MIL-R-36563A
Amendment-2
13 July 1970
SUPERSEDING
Amendment-1
10 January 1970

MILITARY SPECIFICATION

RESUSCITATOR, FIELD, 110 Volt, 60 Cycle,
AC, or 24 Volt, DC

This amendment forms a part of Military Specification MIL-R-36563A, dated 3 October 1969, and is mandatory for use by all Departments and Agencies of the Department of Defense.

FIGURE 1

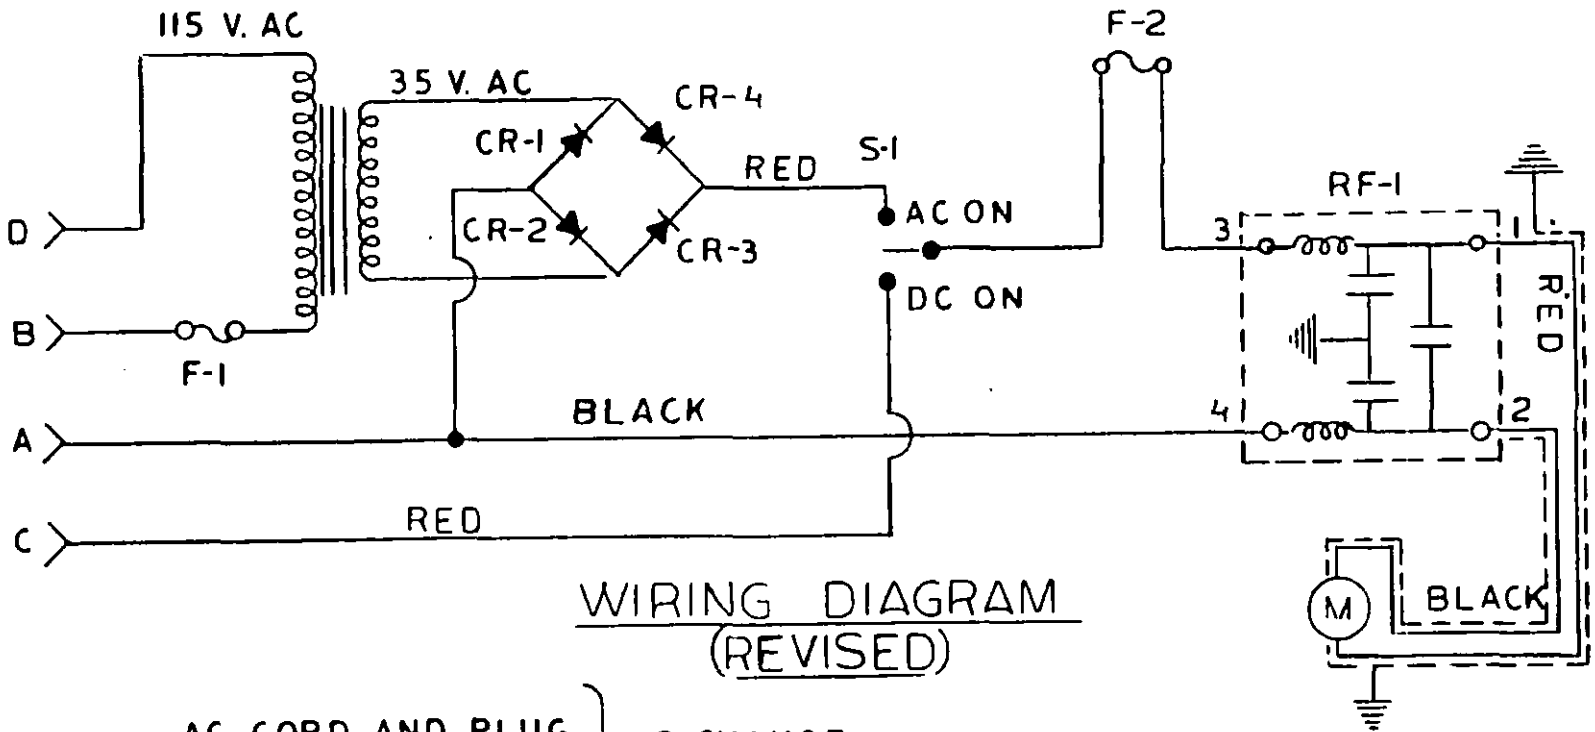
Wiring Diagram, Sheet 4 of Drawing. - Delete present diagram, and substitute new diagram as shown on Figure I.

4. DELETE AND SUBSTITUTE:
"4 RF-1 ALL-TRONICS R.F. FILTER MODEL A 2703 (PART 237)"
